Decision 08-10-017 October 2, 2008

BEFORE THE PUBLIC UTILITIES COMMISSION OF THE STATE OF CALIFORNIA

Rulemaking 07-12-001
(Filed December 6, 2007)

**DECISION ADOPTING UNIFORM CONSTRUCTION
STANDARDS FOR POLE-TOP ANTENNAS**

~~Figure 94.1~~

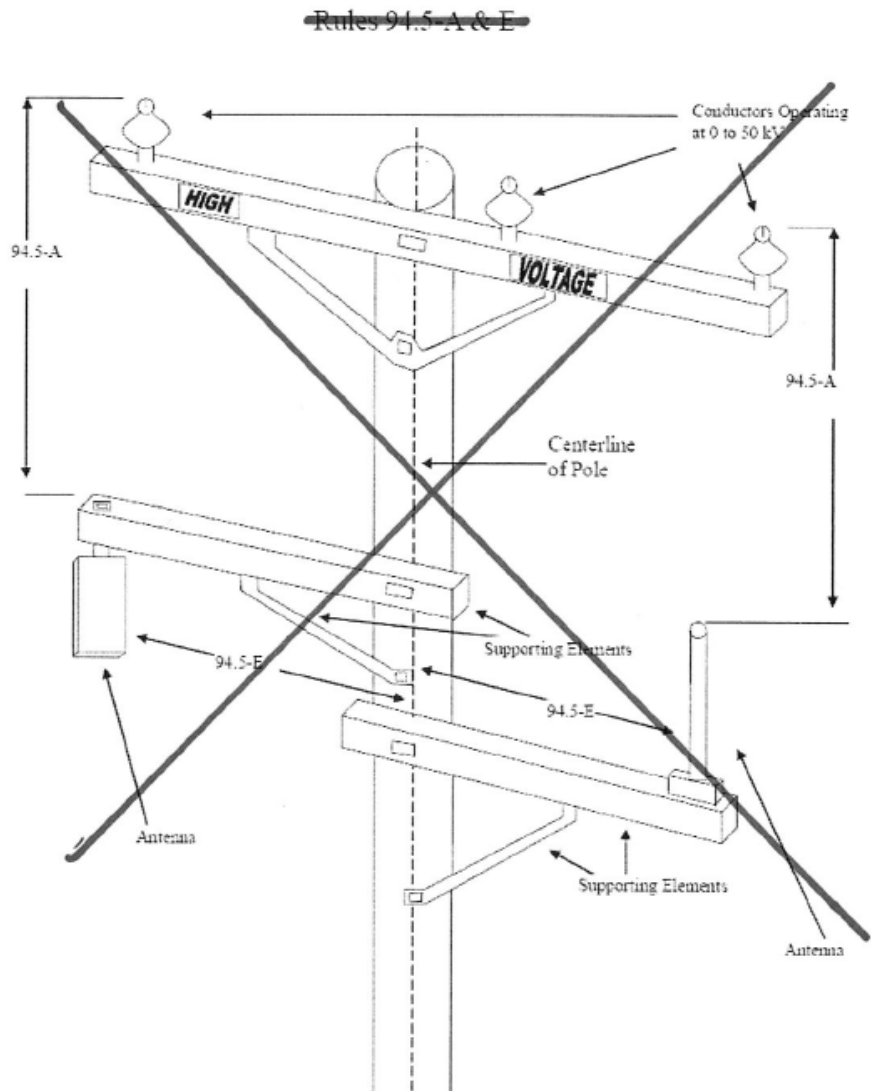
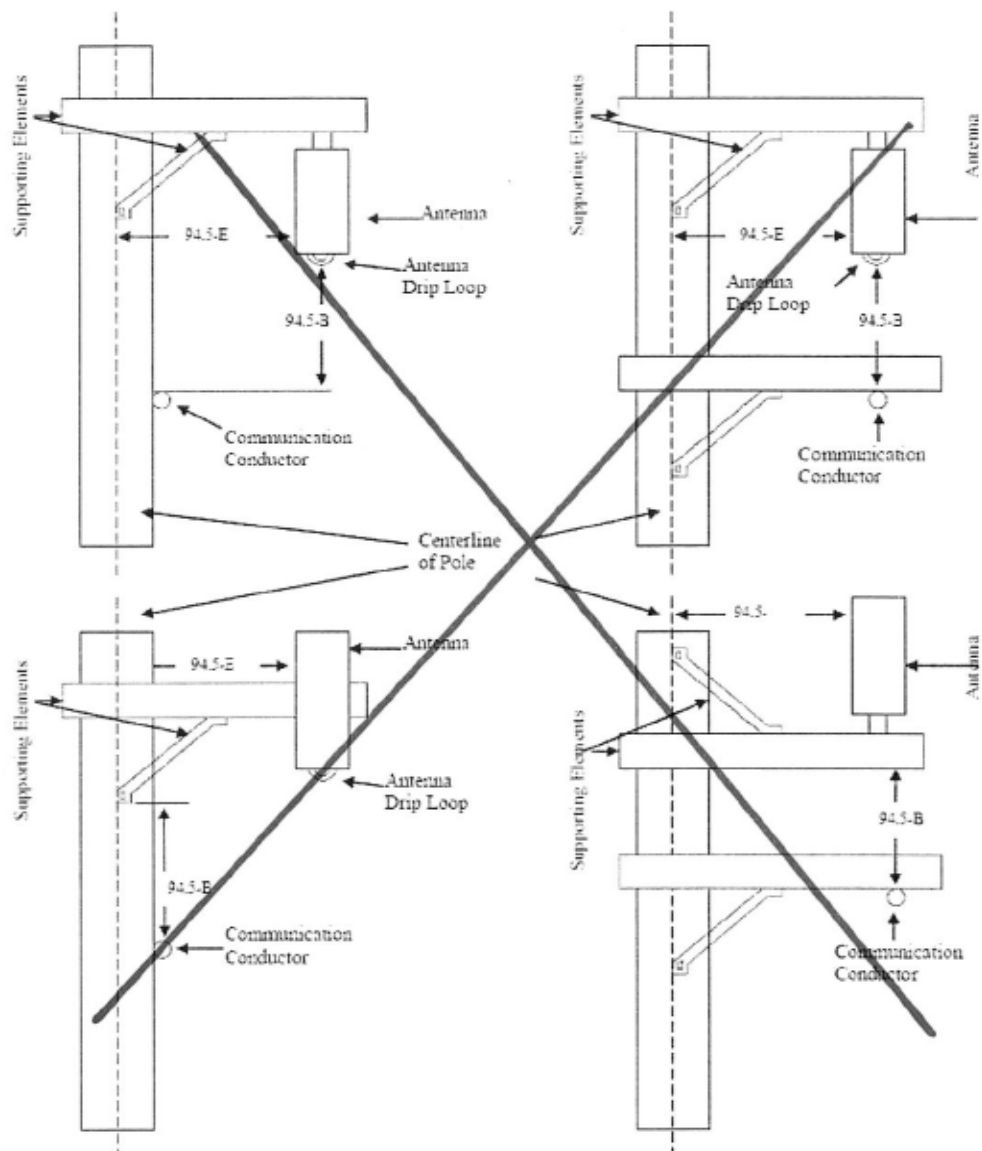
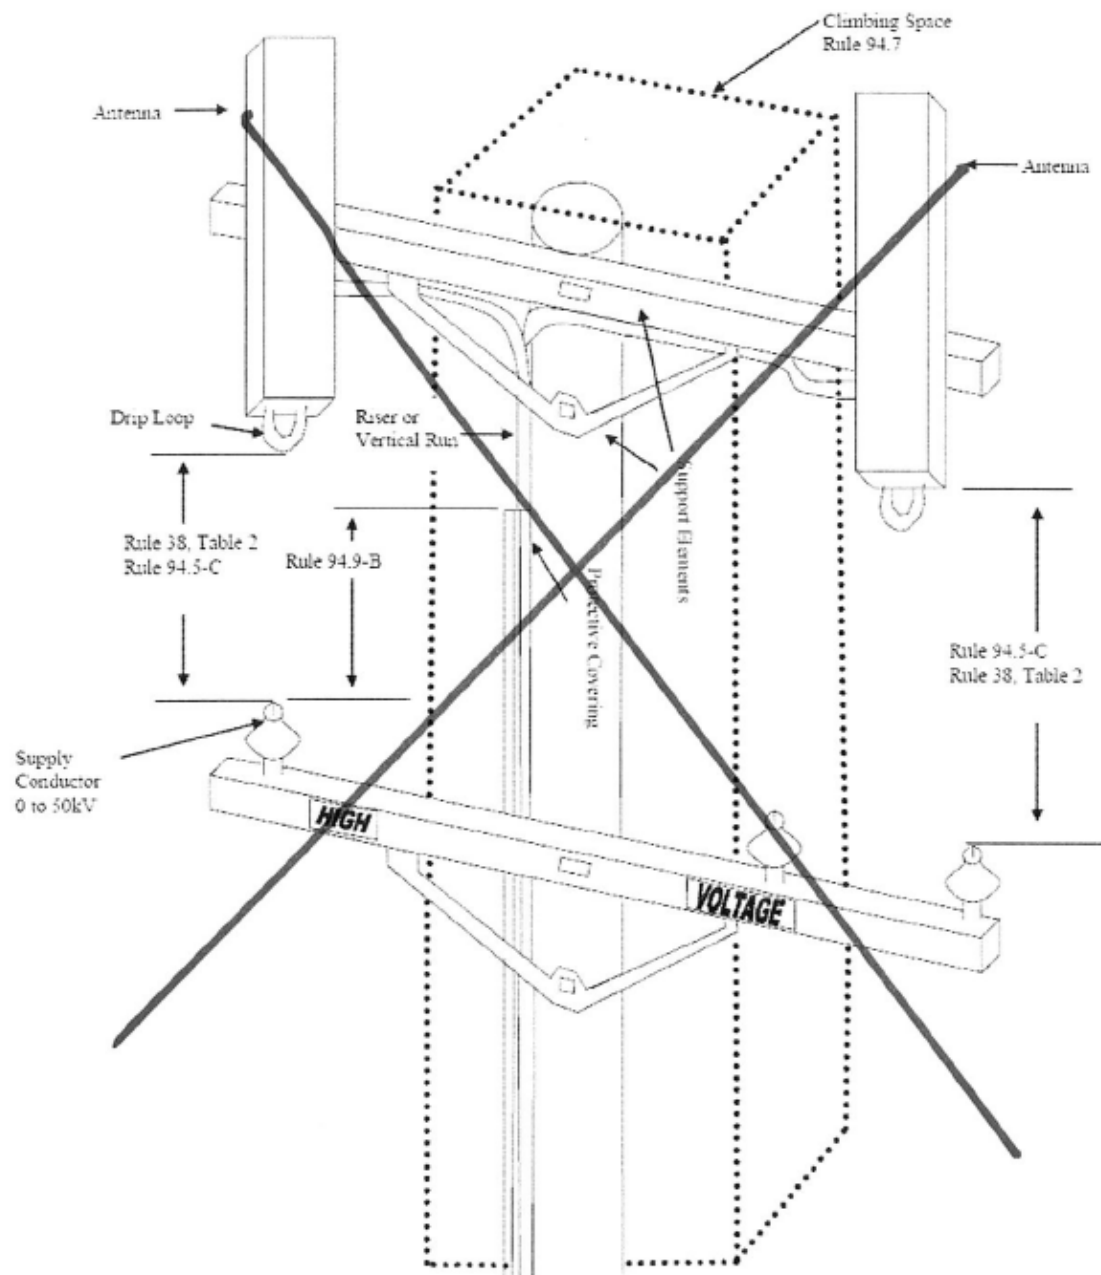
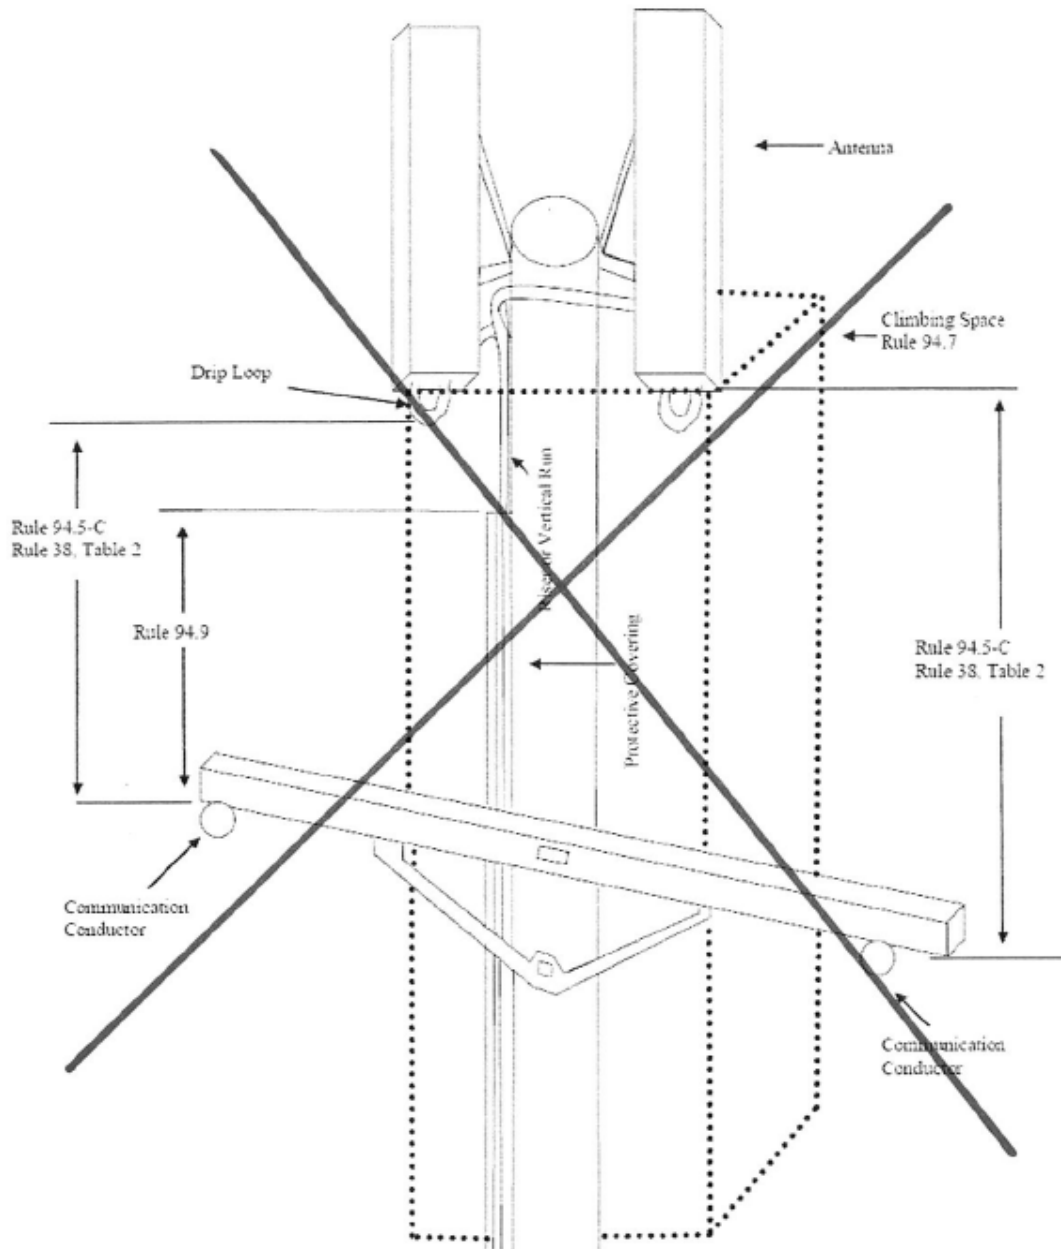
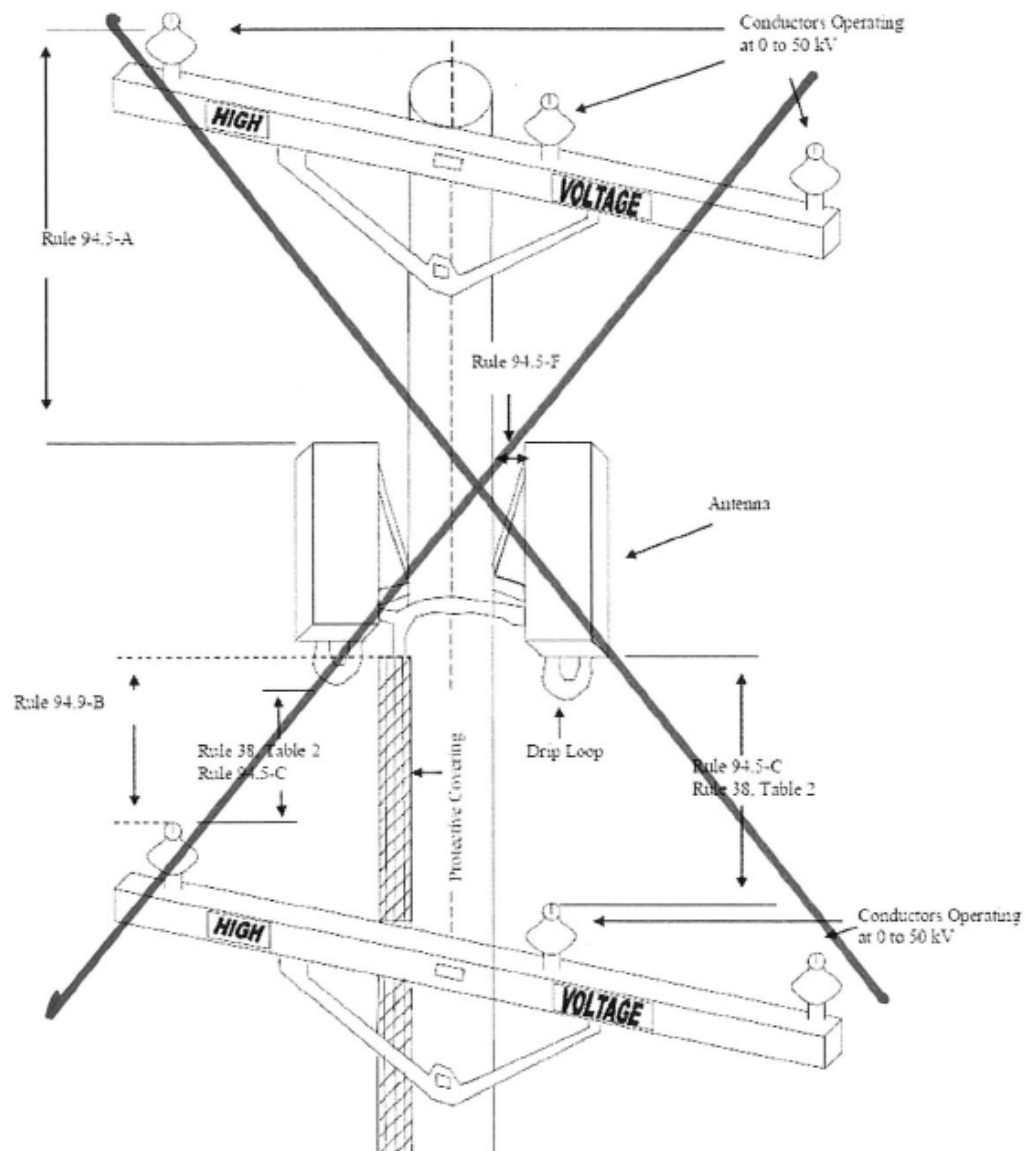
Also, the references to multiple Figures (94.1 – 94.5) were replaced with references to a new composite Figure 94.1.

New 94.6: Renumbered from (original) 94.7, a reference to (original) Figure 94.3 was also removed as parties agreed this reference was no longer needed.

Figure 94-1

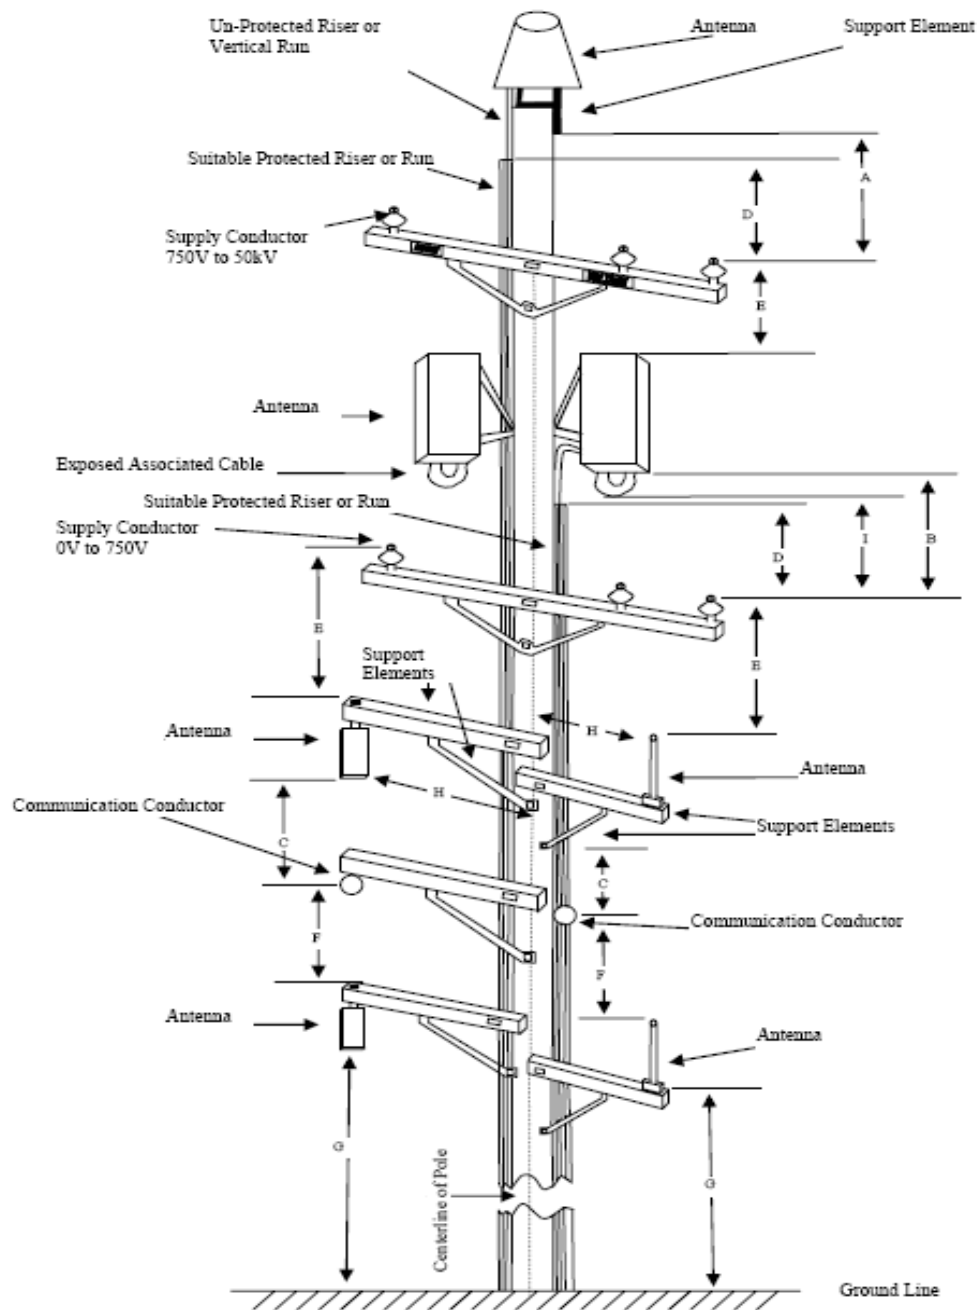
Finally, the TCR proposes to replace four existing diagrams with one new diagram labeled Figure 94.1. The new diagram illustrates in one place all of the vertical and horizontal clearances mandated by the revised Rule 94.

During the afternoon session, attendees discussed revisions to Figures 94.1 – 94.5 and concluded that a new Figure that encapsulates the variety of wireless antenna installations above and below supply and communication lines on a joint-use utility pole would be preferable to five separate Figures.

- A.** Antennas and support elements below supply lines shall maintain a vertical clearance of 6 feet from Supply Conductors operating at 0 –50kV. (See Figure 94-1)
- B.** Antennas and support elements below communication lines shall maintain a 2 ft. vertical separation from communication conductors and equipment. (See Figure 94-1)
- C.** Antennas, associated equipment (e.g. terminations, enclosures) and support elements installed above supply lines and/or communication lines of different ownership attached to the same structure shall maintain the vertical clearances specified in Rule 38, Table 2, Case 21, Columns A - H.

- D.** Antennas, associated equipment (e.g. terminations, enclosures) and support elements, installed above supply lines and/or communication lines of different ownership, shall maintain the radial clearances from unattached supply and communication lines specified in Rule 38, Table 2, Case 3.
- E.** Antennas shall maintain a 2 ft. horizontal clearance from centerline of pole when affixed between supply and communication lines or below communication lines. (See Figure 94-1)

- F.** Horizontal clearances from centerline of the pole for Antennas, associated equipment and support elements, affixed between supply lines or at the top of a climbable pole, are not specified, but must be arranged so that the pole may be climbed safely.
- G.** Antennas shall have a vertical clearance above ground as specified in Rule 37, Table 1, Column B, Cases 1 - 6a. (See Figure 94-1)
